**PCN# 20240621001.1**

**Qualification of TIPI as additional Assembly site for select devices  
Change Notification / Sample Request**

**Date:** June 21, 2024

Sample product shipping label (not actual product label)

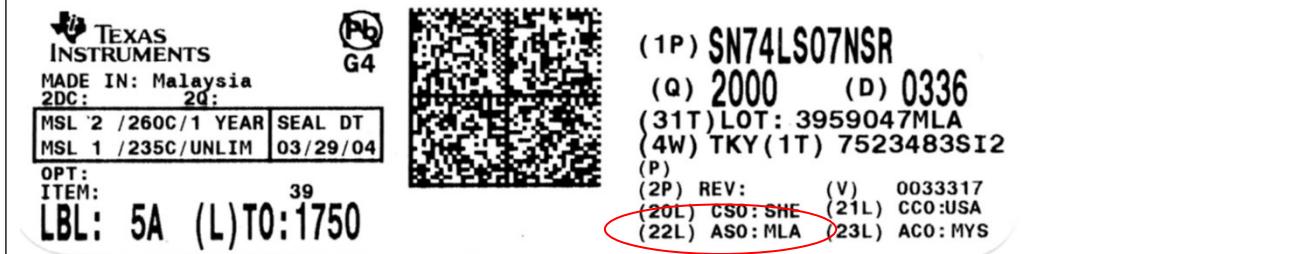
#### Changes to product identification resulting from this PCN:

Assembly Site	Assembly Site Origin (22L)	Assembly Country Code (23L)	Assembly City
ASECL	UAJ	TWN	Chung-Li
<b>TIPI</b>	<b>PHI</b>	<b>PHL</b>	<b>Baguio City</b>
